Optimized Power Coupling Inductance Day 2

Adjustments after 1st day of conference

Text Modification to allow variable L_{pod}

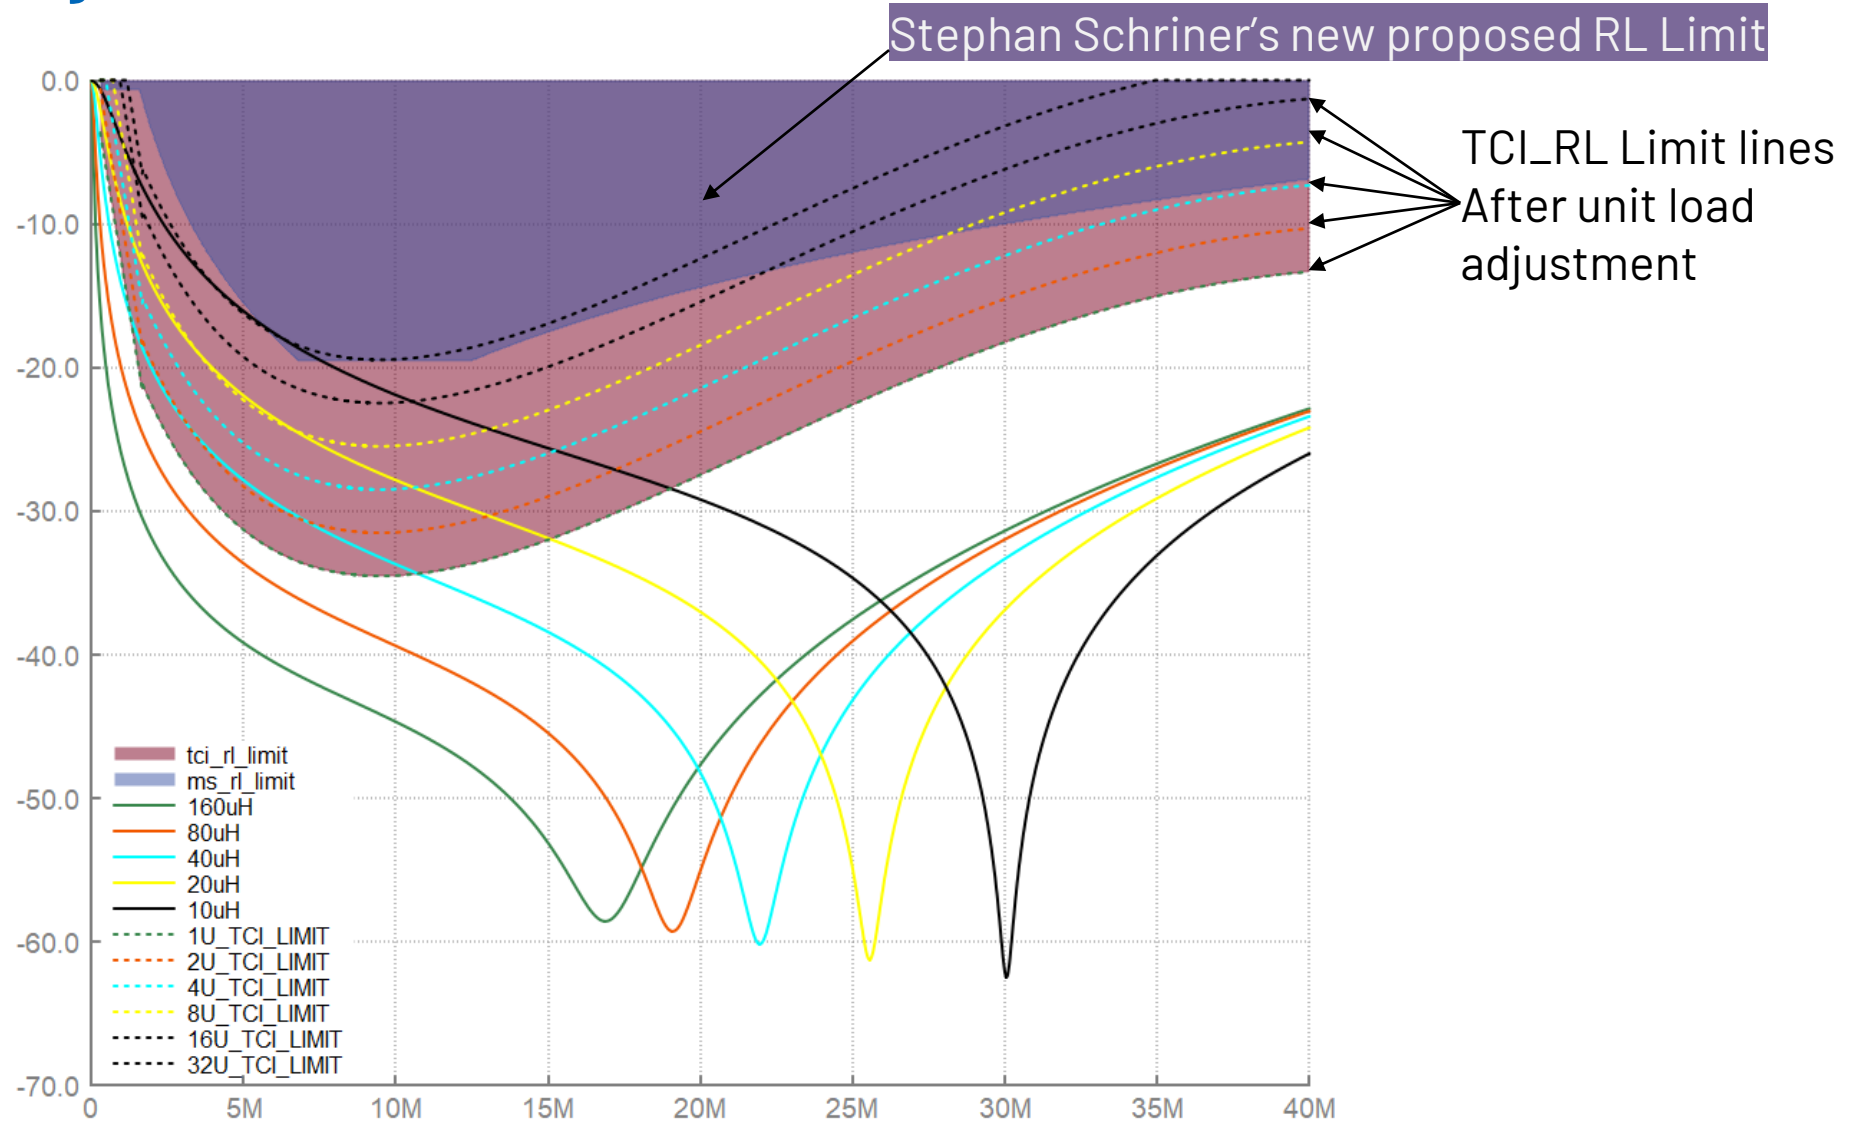
In clause 189.6, insert new section 189.6.1 MPI Return Loss with text:

“When the MPI is a TCI, the TCI return loss at TC1 and TC2 shall meet the values determined using Equation (188–7) with the other trunk TC (i.e., TC2 or TC1, respectively) terminated in 100 /OHMS with a DTE or simulated DTE load present at the TCI, plus $10 \cdot \log_{10}(N_{load})$, where N_{load} is the maximum number of unit loads for the DTE. (where /OHMS is the symbol for Ohms)”

In clause 188.9.2, insert a new first sentence

“When the TCI is also an MPI, the return loss of the TCI complies with the return loss of 189.6.1.” Change the beginning of the following sentence to read, “When the TCI is not an MPI, the TCI return loss at TC1 and TC2 shall meet the values determined using Equation (188–7) with the other trunk TC (i.e., TC2 or TC1, respectively) terminated in 100 /OHMS with a DTE or simulated DTE load present at the TCI.” (where /OHMS is the symbol for Ohms)

Unit Load Adjustable Limits

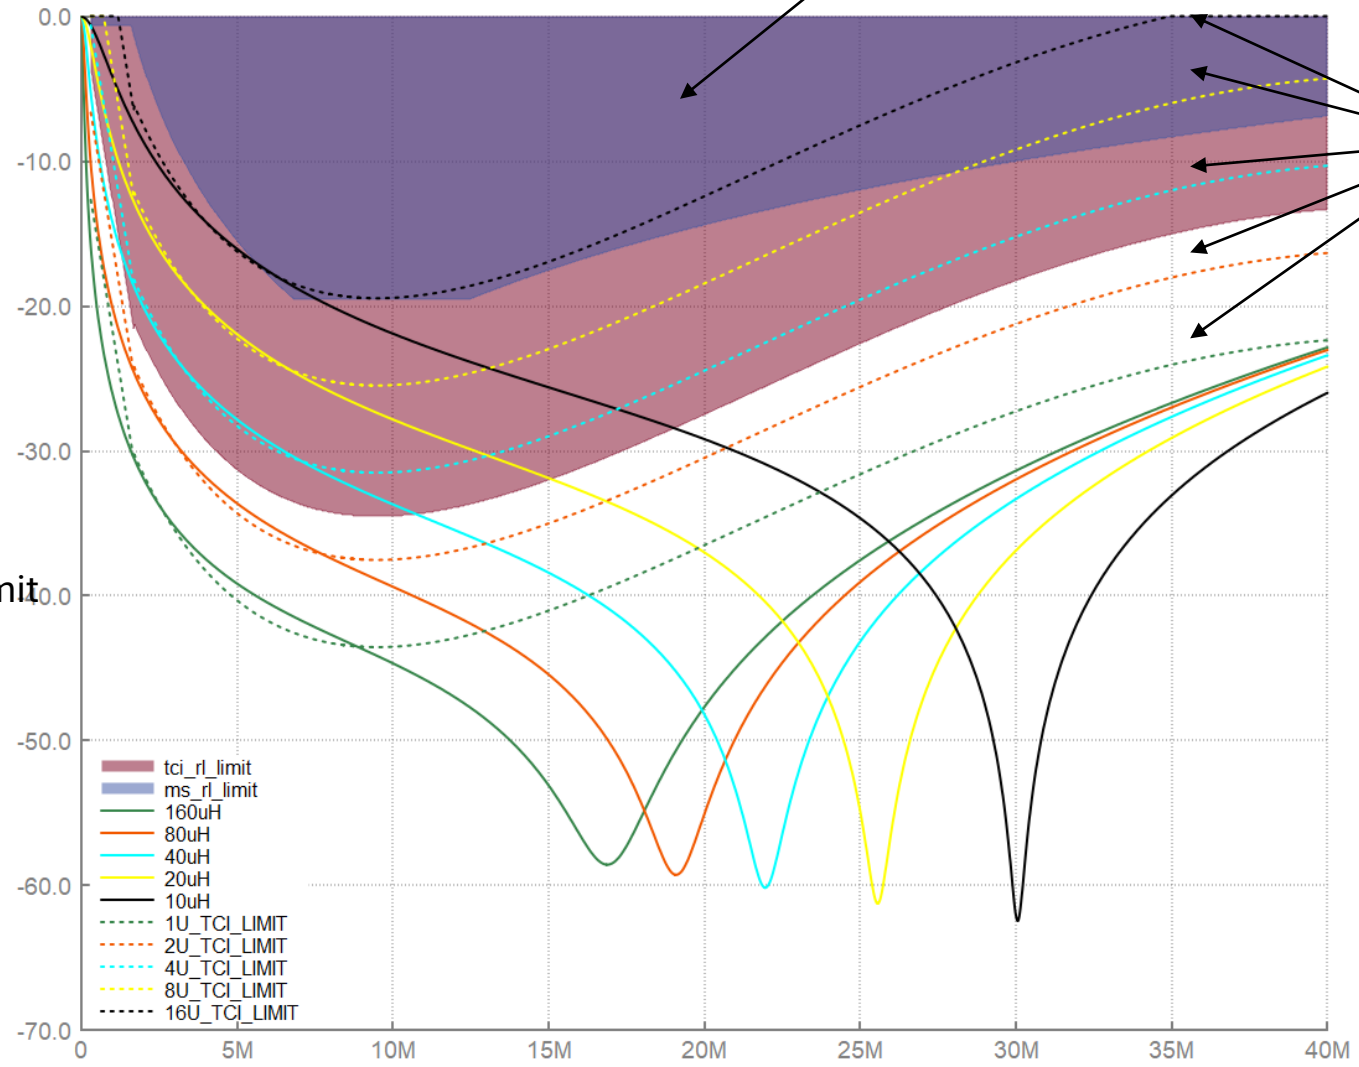
GZ Proposed Adjustable Limits

Equation (188-7) ...
 plus $10 \cdot \log_{10}(N_{load})$,

TCI_RL Limit lines
After unit load
adjustment

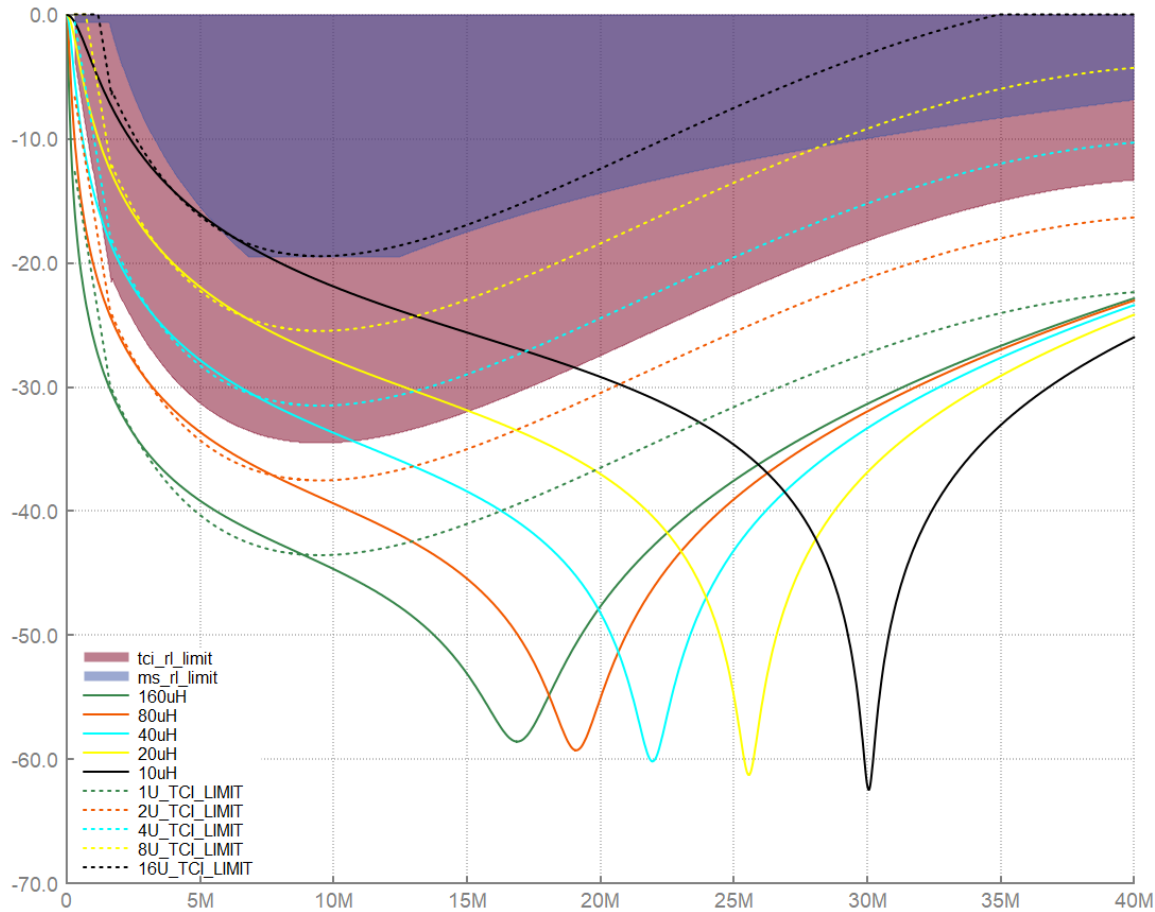
Stephan Schriener's new proposed RL Limit

Equation (188-7) ... plus
 $10 \cdot \log_{10}(N_{load}^2 / 8)$,

Lines fit better, but 1U device limit
Dropped by ~10dB

Comparing linear and log X scales

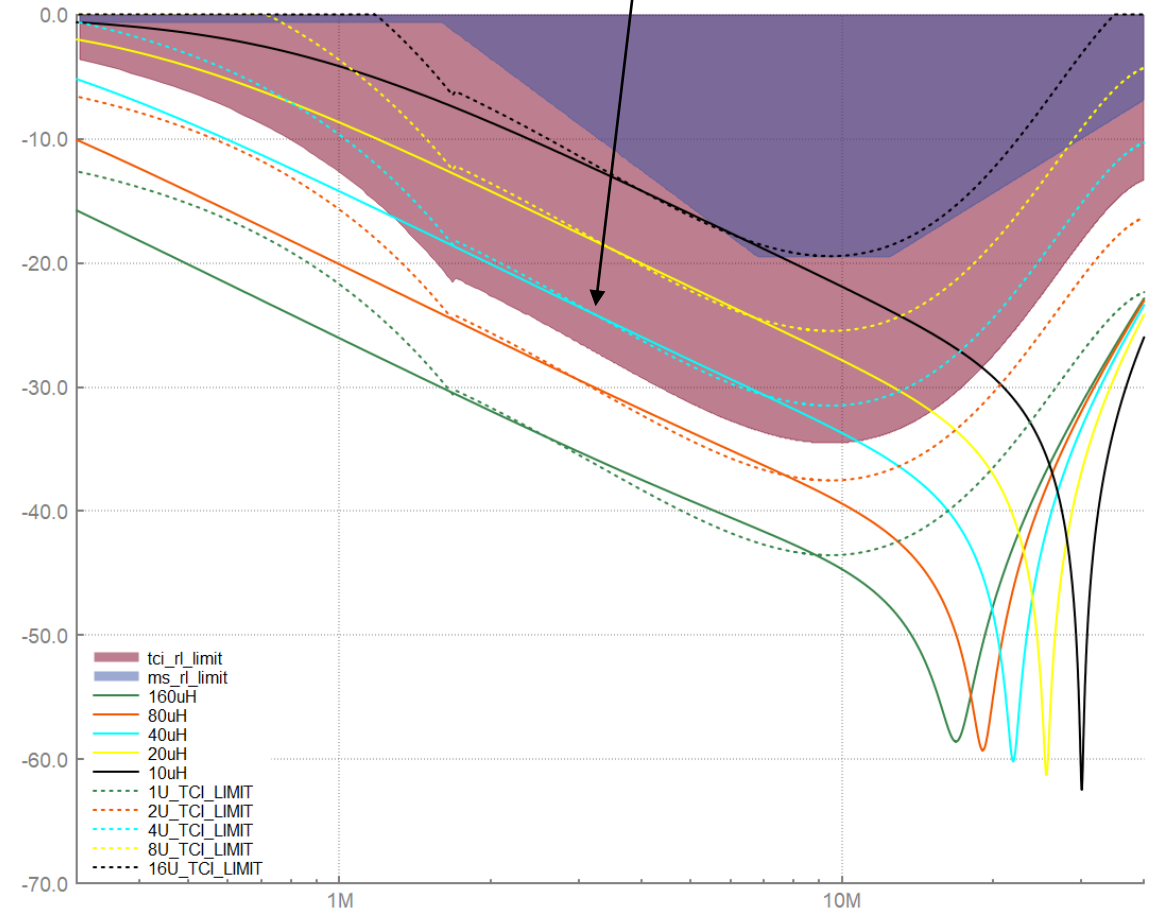
Inductors have -20dB / decade characteristic

Todo:
Analyze how to move the low frequency line without affecting the high frequency RL
Comment against D2.1 with update

Power Coupling Inductance Compliance

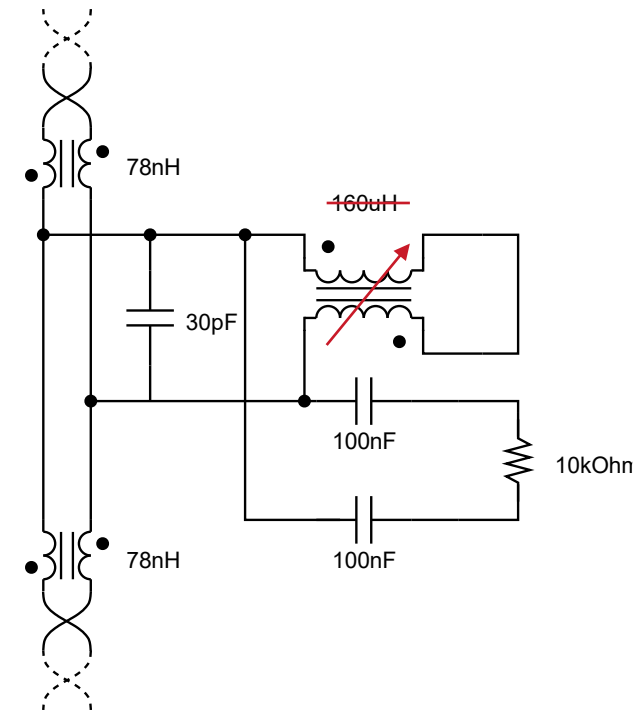
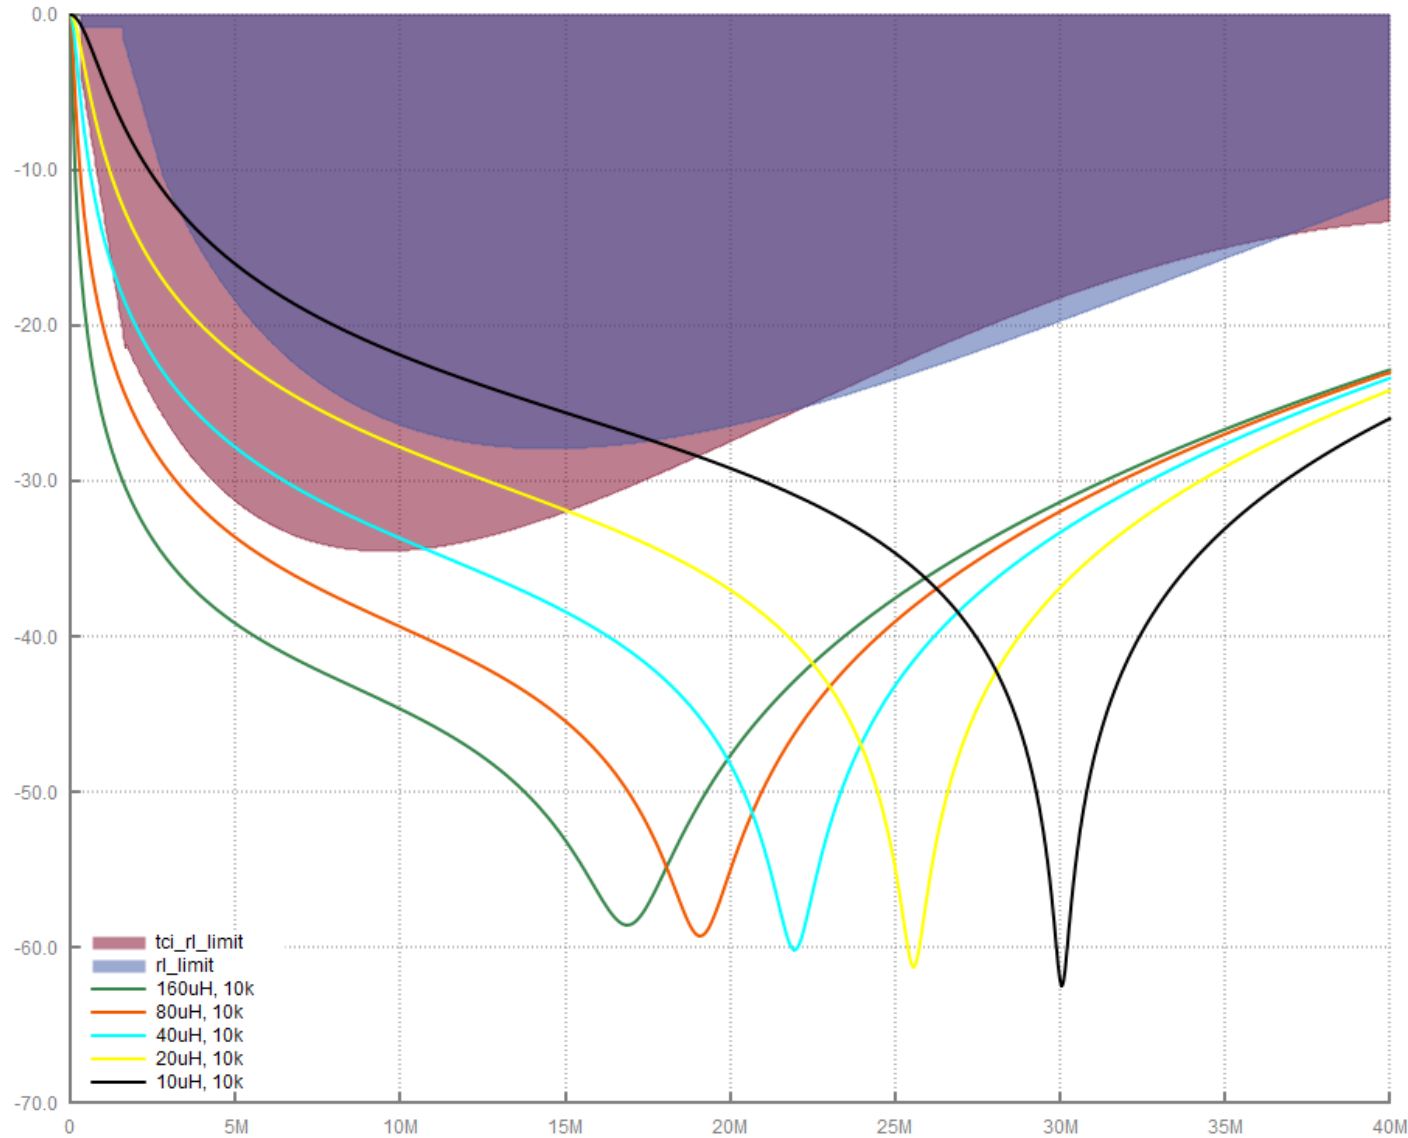
In 802.3da Draft 2.0, the power coupling inductance is limited by the TCI Return Loss limit specified in clause 188

The TCI return loss limit is calculated for nodes with ~80uH power coupling inductance

We need it to accommodate ~10uH for 16U devices and 160U for 1U devices
